MASTER PLAN OF DRAINAGE – SUBAREA 2 – AMENDMENT

**CITY OF CHINO SPHERE OF INFLUENCE
CHINO AGRICULTURAL PRESERVE AREA**

MASTER PLAN OF DRAINAGE - SUBAREA 2 – AMENDMENT

AMENDMENT TO
**MASTER PLAN OF DRAINAGE
 SUBAREA 2**

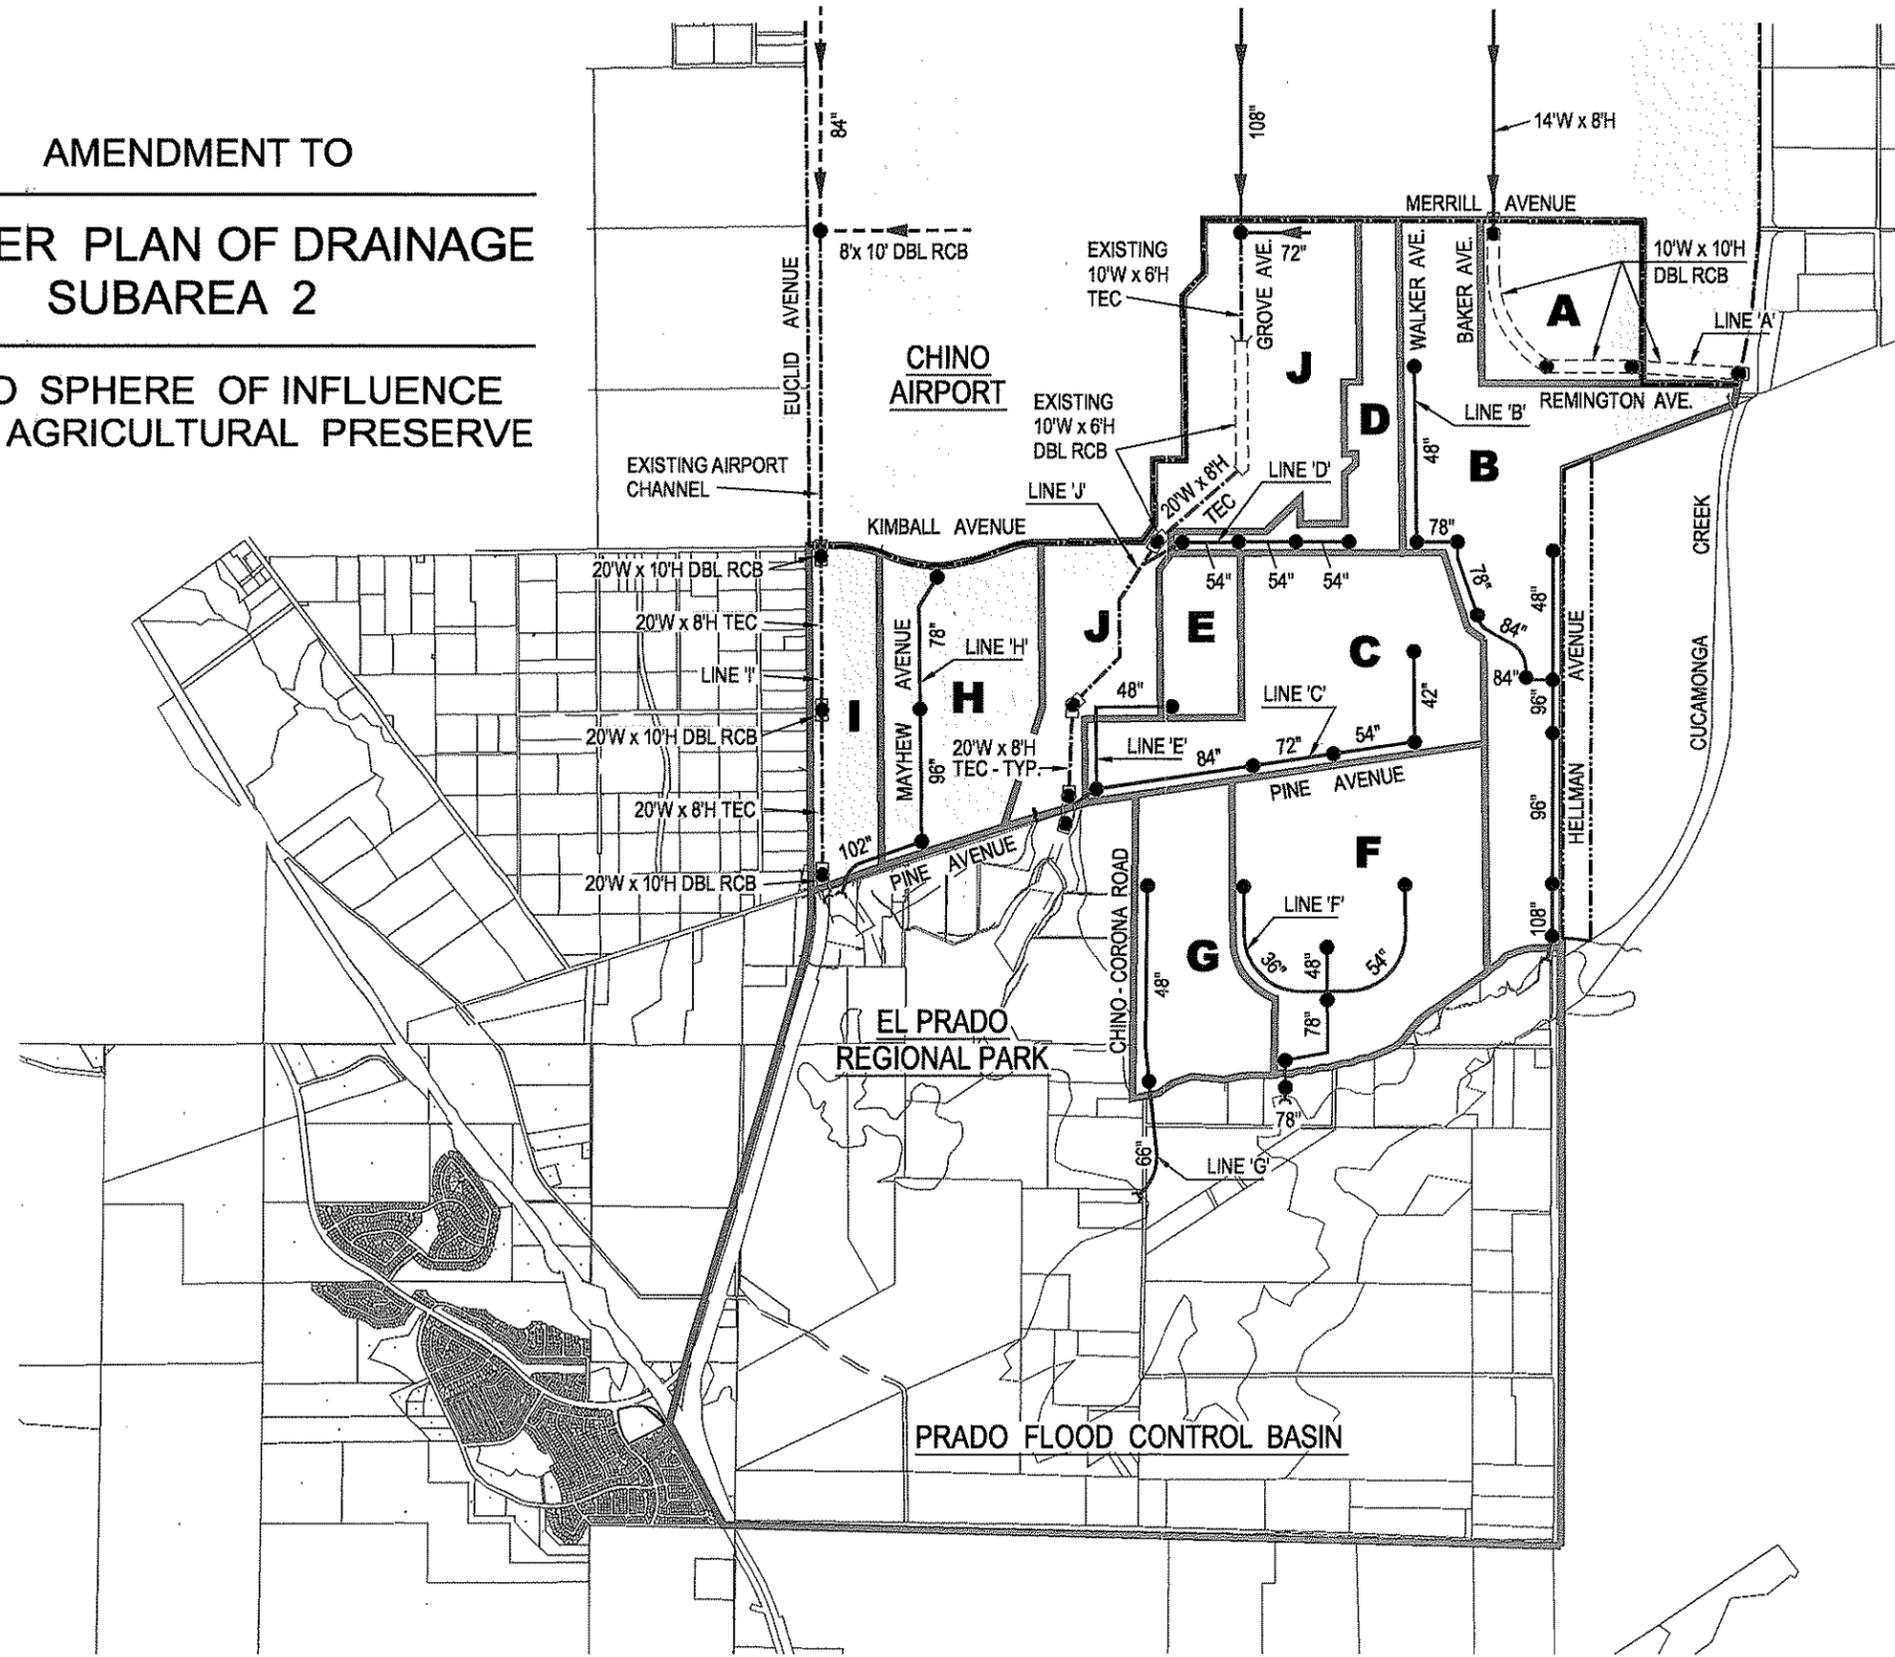
The calculations determined the need for a 54" reinforced Concrete pipe (RCP) for the main line from just west of Walker Avenue to Mill Creek Avenue (Cucamonga Avenue) at the outfall. The ultimate peak runoff discharge at the outfall calculated to be $Q_{100} = 140.664$ cfs. As a result of the storm drain flowing under pressure in this reach, the pipe size was increased to 54" to keep the hydraulic grade line (HGL) a few feet below gutter flowline.

The calculations did verify the need for a future 48" RCP in Walker Avenue to be constructed by others when the land north of Kimball Avenue is developed. The original Master Plan recommended a 78" RCP draining from Walker Avenue into the west bound Kimball Avenue storm drain and now that main line will drain east, rather than west.

The storm flows intercepted along Kimball Avenue will be conveyed westerly by a 54-inch diameter storm drain, as proposed by this "Amendment". This 54-inch RCP storm drain will carry runoff to Channel "J", southwesterly of the intersection of Kimball Avenue and Mill Creek Avenue (Cucamonga Avenue), in accordance with the original Master Plan of Drainage.

The results of the study calculations for this "Amendment" provides 54" RCP storm drain for the full length of Kimball Avenue draining west as Line "D" and 78" RCP for Line "B" line draining east. The drainage facilities proposed for Drainage Basin Area "J" remain as proposed in the original Master Plan of Drainage. Channel "J" will be a 20' wide, by 8' high Trapezoidal Earthen Channel with 20' x 8' double reinforced concrete box culverts crossing Kimball Avenue, Bickmore and Pine Avenue.
